City of Surrey
PLANNING & DEVELOPMENT REPORT

File: 7917-0592-00

Planning Report Date: September 16, 2019

to allow for the development of a one-storey industrial warehouse building. A variance is requested to reduce the minimum side yard (south) setback requirement as well as the minimum landscape requirement along the west lot line.

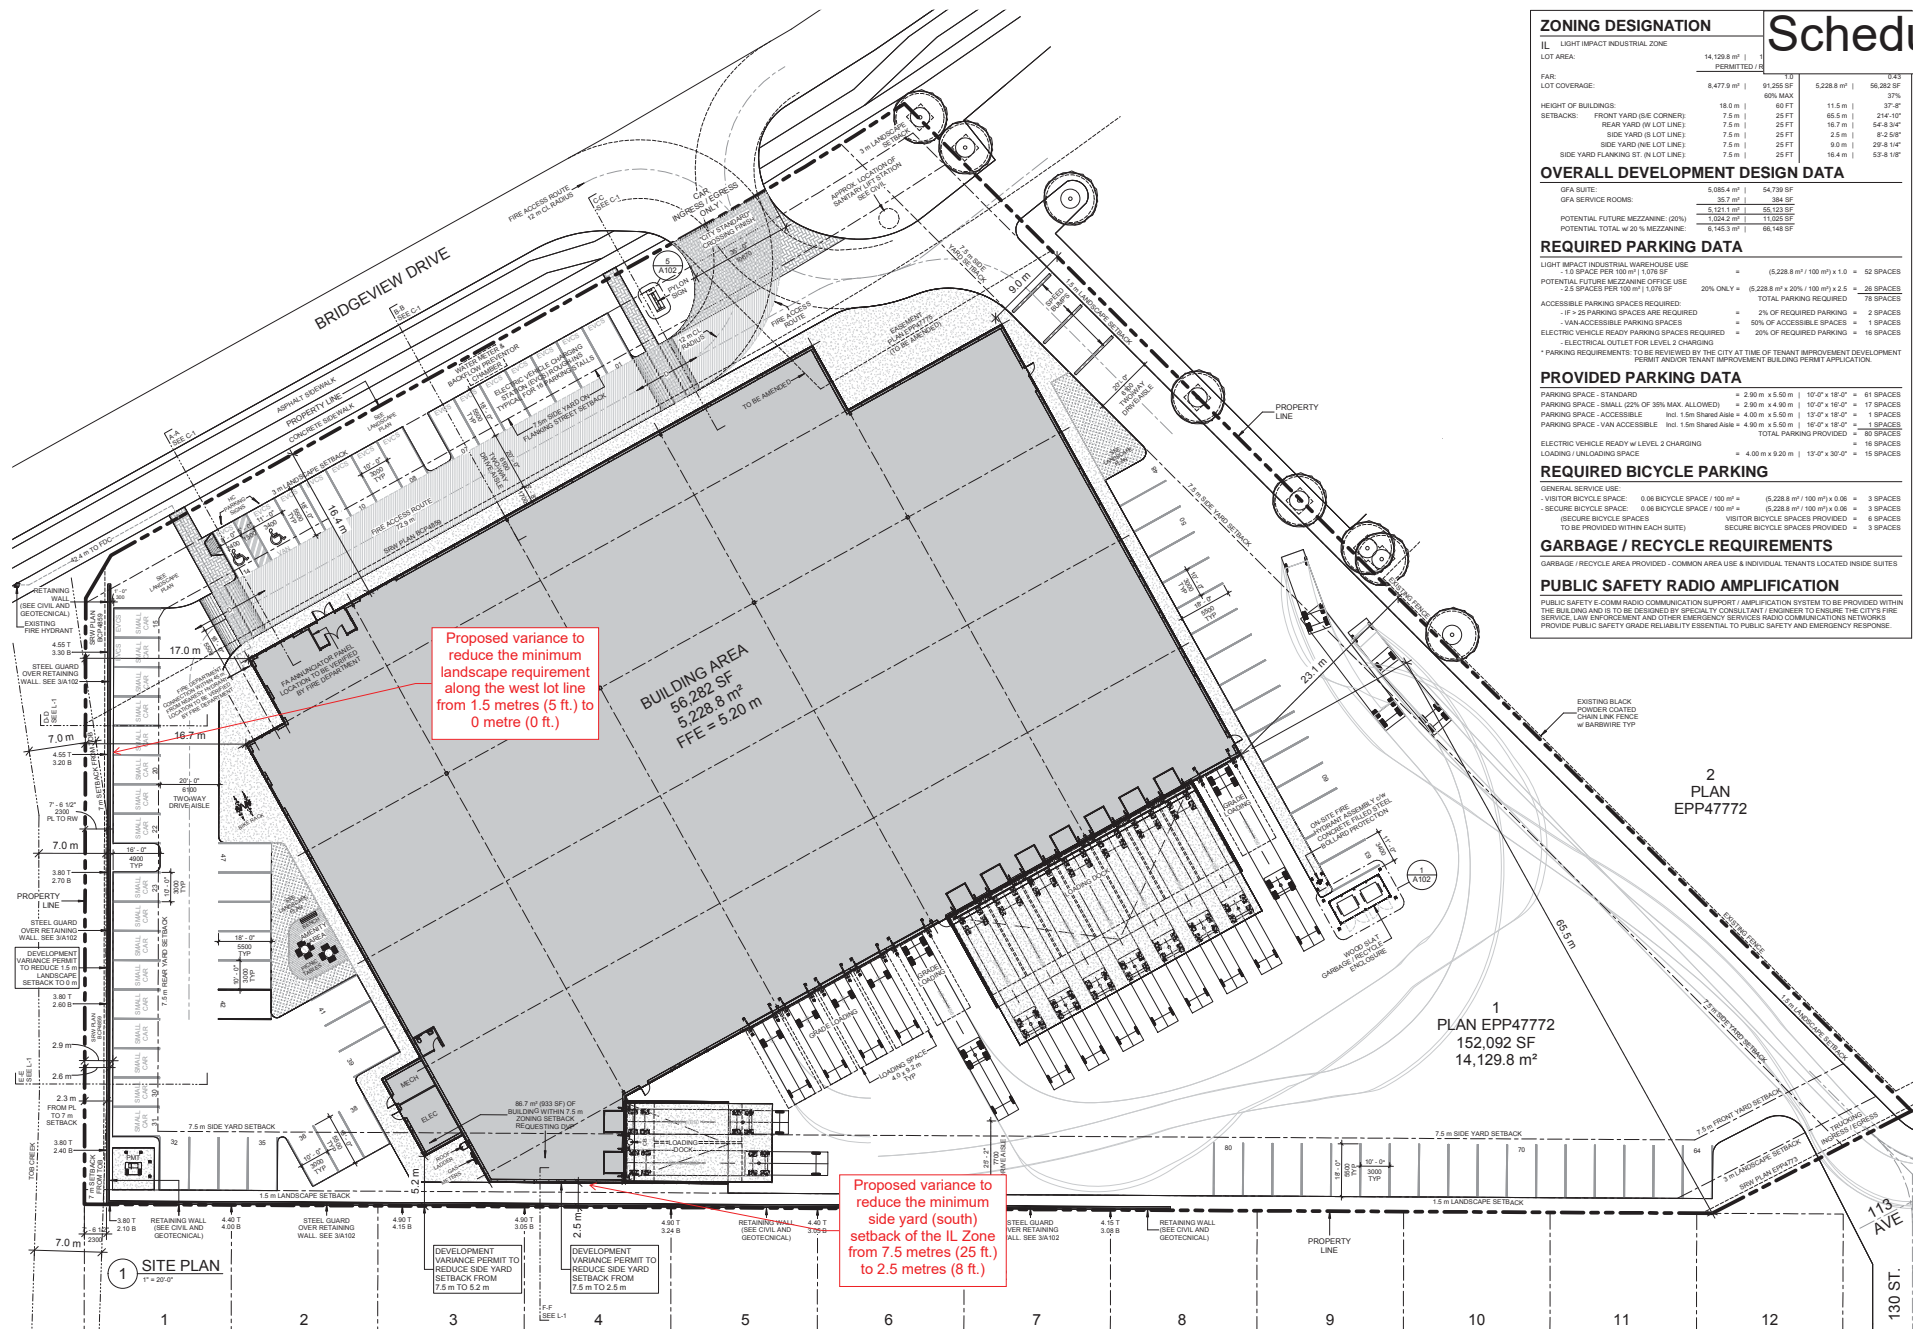
Proposed variance to reduce the minimum landscape requirement along the west lot line from 1.5 metres (5 ft.) to 0 metre (0 ft.)

Proposed variance to reduce the minimum side yard (south) setback of the IL Zone from 7.5 metres (25 ft.) to 2.5 metres (8 ft.)
